# Service Bulletin

Bulletin No.: 22-NA-198

**Subject:** Information on Dimpling of Front Fascia Due to Incorrect Front Splitter Fasteners Installed at PDI

Brand:	Model:	Model Year:		VIN:		Engine:	Transmission:
		from	to	from	to		
Chevrolet	Corvette Z06	2023	2024	—	—	—	—

6163500

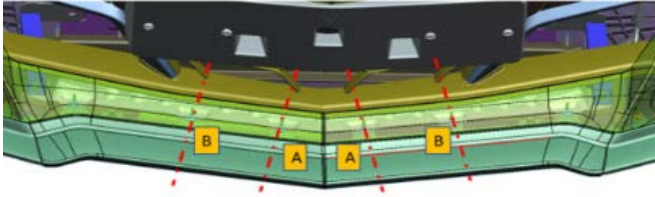
During the installation of the front splitter kit, it is important to install using the correct fasteners.

There are four long fasteners included in the front splitter kit. They should **NOT** be used due to the longer fasteners possibly creating a dimple on the front fascia.

Fasteners A and B — Should use part number 11547755

**Important:** There will be 4 extra bolts of Part Number 11589012 in the original hardware kit after performing installation. These bolts can be discarded.
